Service Information

Category F	Technical	Ref. No. E011/15	Page 1 of 2
Coverage <input type="checkbox"/> Distributor only <input checked="" type="checkbox"/> Please inform your dealers		Date Issued July 8, 2015	
Please convey this information to your <input type="checkbox"/> Director <input checked="" type="checkbox"/> General Manager <input checked="" type="checkbox"/> Warranty Dept. <input checked="" type="checkbox"/> Parts Dept. <input checked="" type="checkbox"/> Training Dept. <input checked="" type="checkbox"/> Field Rep.		Date Revised	
Applicable Model MX-5(ND)		Applicable Countries or Specifications Worldwide

Subject: Abolishment of High Pressure Fuel Pipe Cover

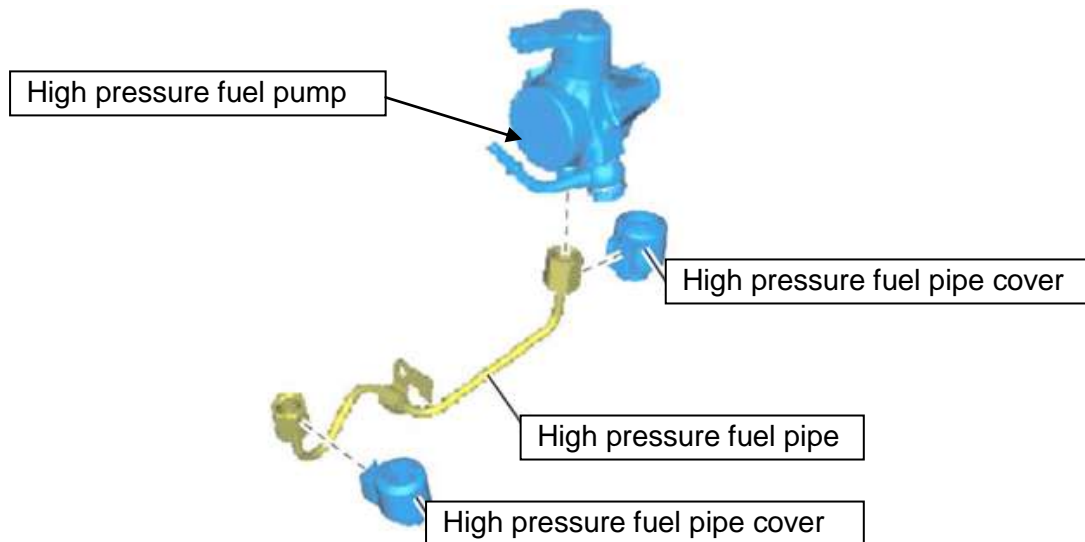
To improve serviceability, the high pressure fuel pipe cover (Part No.: P51B-13-2KE) has been abolished.

Although the high pressure fuel pipe cover is specified by the workshop manual as a replacement part, it is not necessary to install the new part during the high pressure fuel pipe removal and installation because it will not affect the performance and quality without the cover.

The workshop manual will be updated.
